**Snowdonia Aerospace Airspace Change Proposal  
Design Options Development (Stage 2A), ACP-2019-58  
Llanbedr Danger Area (DA)**

**Annex 1 - Supporting Evidence**

## Design Options for Airspace Change, ACP-2019-58, Llanbedr Danger Area (DA) – draft for discussion

Figure 1 – Draft airspace design Option #1 for ACP-2019-58, Llanbedr Danger Area (DA)

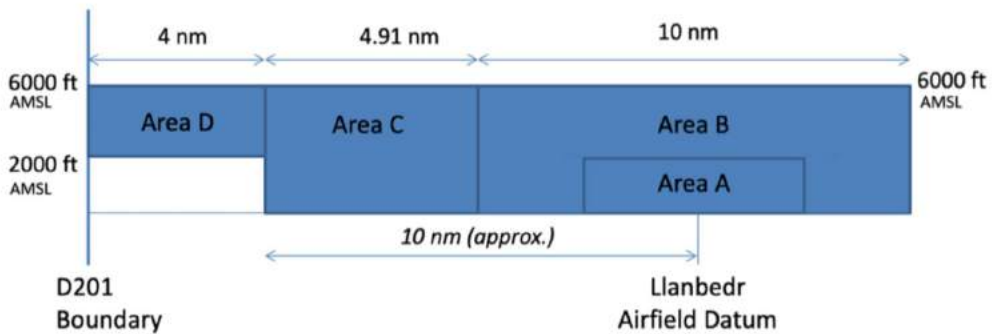
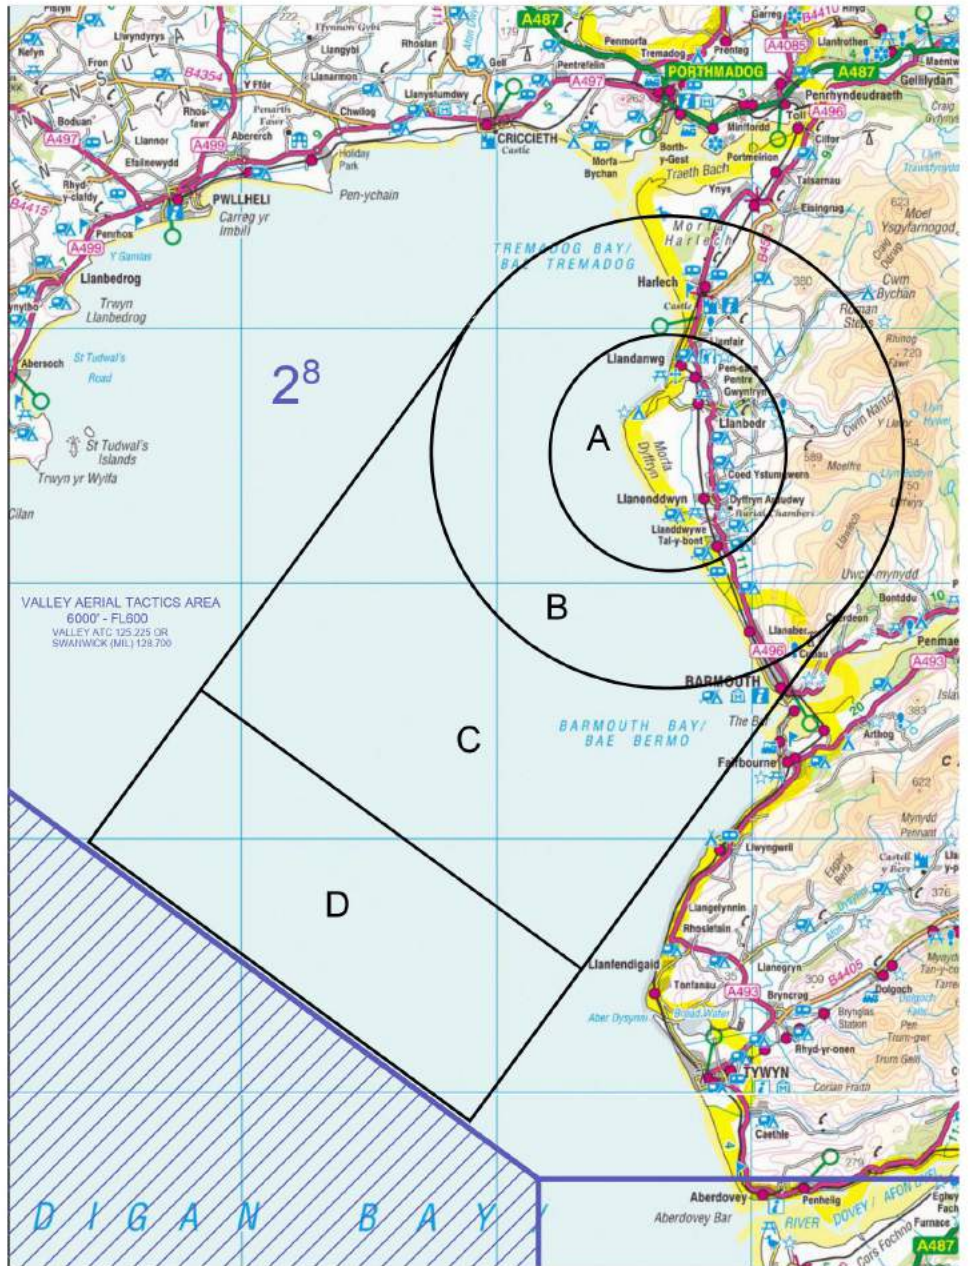
As per the designs we would be affected by being in designated Area B in Design 1 and Area F in Design 2.

This seems quite a departure from how the plans were described in the initial brief where it seemed as though the majority of the DA would be out to sea i.e. if you were to bisect Areas A and B from Option 1 in parallel with the southern perimeter of Area D.

As the designs currently stand, I am completely opposed to Option 1, and would only be supportive of Option 2 if Area F were removed from the DA altogether.

I prefer option one on the basis that it is easier to assimilate, reducing cockpit workload.

The uplands under airspace area E2 (being part of area B in Option 1) are of immense environmental value and include:

Figure 2 – Draft airspace design Option #2 for ACP-2019-58, Llanbedr Danger Area (DA)

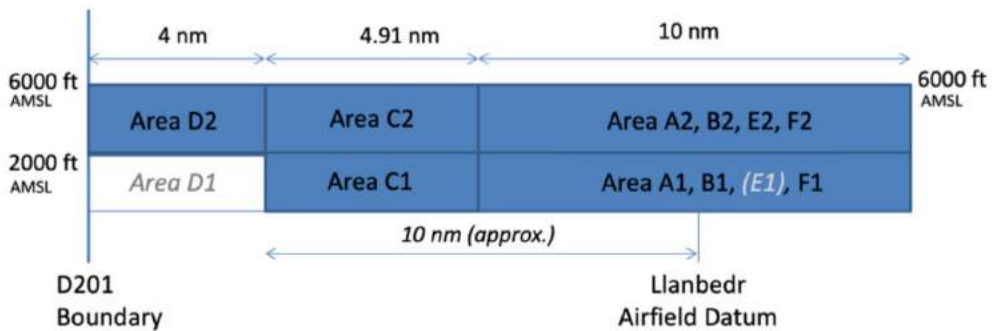
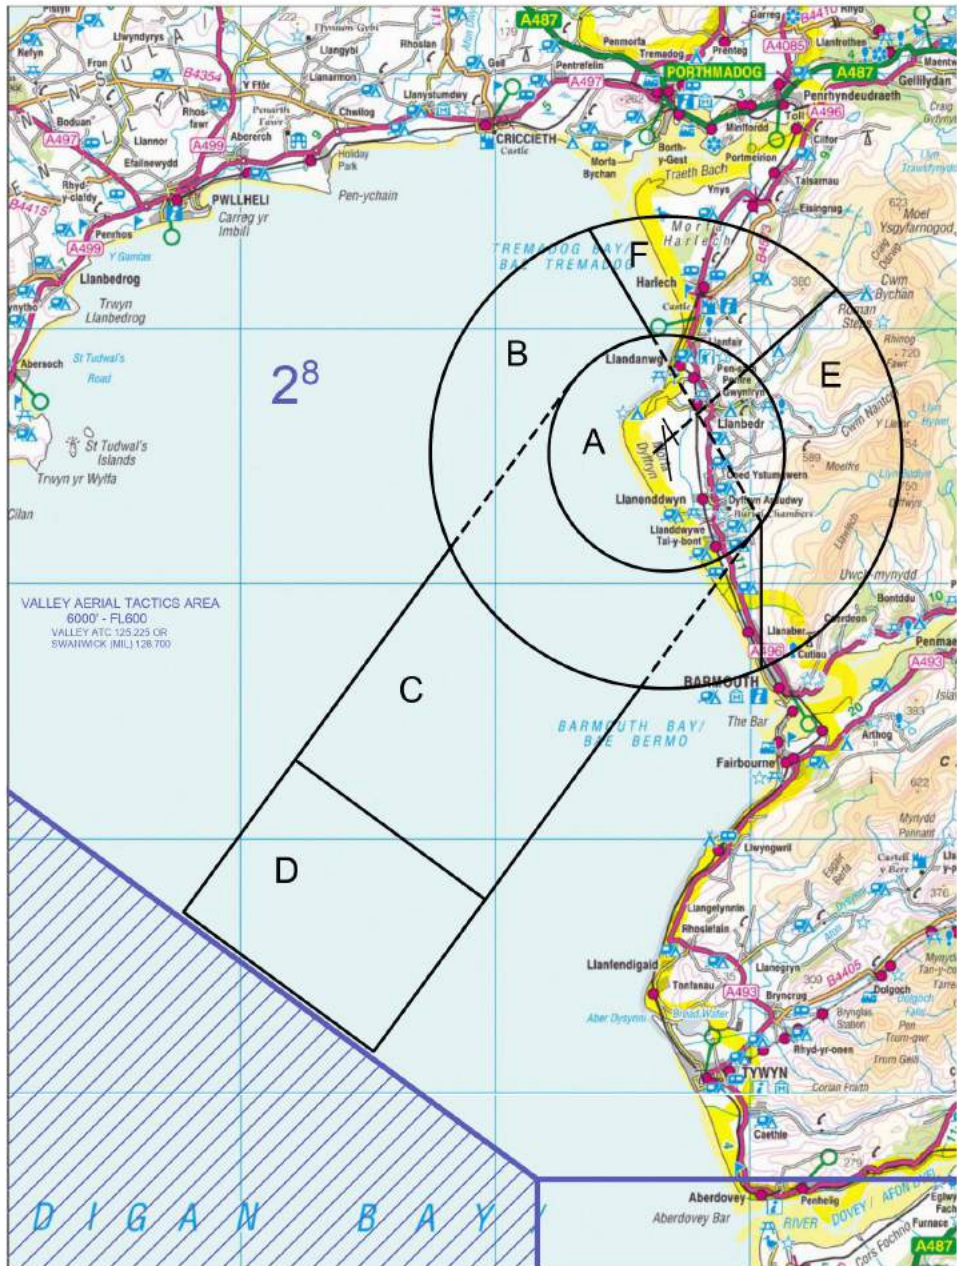
1. The width of C and D is reduced in option 2 and I believe this is good as I cannot see the reason for it to be so wide as in option 1. If the unmanned experimental aircraft needs the width of D and C as outlined in option 1 then I worry about their wider safety. Also, I genuinely believe we should be trying to keep as much G classified airspace as possible.

I would also suggest that F1 is also not included or not used within the danger area as is the case with zone E1 and my reason for this is that F1 is the most built up area containing Llandanwg and Harlech. I would suggest experimental unmanned aircraft operating at a low level in this area is unwise and by not using this zone it allows GA to use this area as an approach path.

Thank you for adding option #2. I believe that the extra flexibility this provides will be very useful as it will allow you to only activate the volume of airspace that is required for any particular operation and leave the remaining volumes available for use by other traffic. It leaves volume E1 out of the danger area and allows A2, B2, E2, F1 and F2 to be left out when not needed. These are the volumes most likely to be used by gliders.

Our main concern is the draft proposal for an area of inland airspace over one of the most tranquil parts of the National Park (Area E) to be used as 'an extended area for upland/mountain operational testing'. We request that draft Danger Area proposals are reconsidered in order to avoid significant harm to public enjoyment of the special qualities of this part of the National Park.

- implicitly included in Option 1, taking place in an overland segment of area B from sea level to 6000ft AMSL
- explicitly included in Option 2, taking place in area E2 from 2,000 to 6,000 ft AMSL (with area E1 extending from the surface to 2000ft altitude being 'unused to keep experimental aircraft clear of the Rhinog Mountains').

SSS therefore asks that the proposed Llanbedr Danger Area is modified to take into account the paragliding and hang-gliding activities that currently take place around Harlech and the surrounding area so that flying activities are unaffected in areas F1 and F2.

<p>Your response In Proposal one area B may have some impact and in proposal two area F, E and B will have some impact because gliders need to use the ridges to the north and west of Llanbedr to seek out lift. The options afforded by the two height bands and in the proposal two by the division into areas F, E and B may mitigate this to some extent.</p>
<p>9. Are there any local development projects, or existing particularly noise sensitive areas, that the CS should be aware of?</p>
<p>Your response Not relevant to this stakeholder.</p>
<p>10. Please advise us of any other issues or constraints you feel the CS could consider when designing its new airspace.</p>
<p>Your response please provide details. None</p>
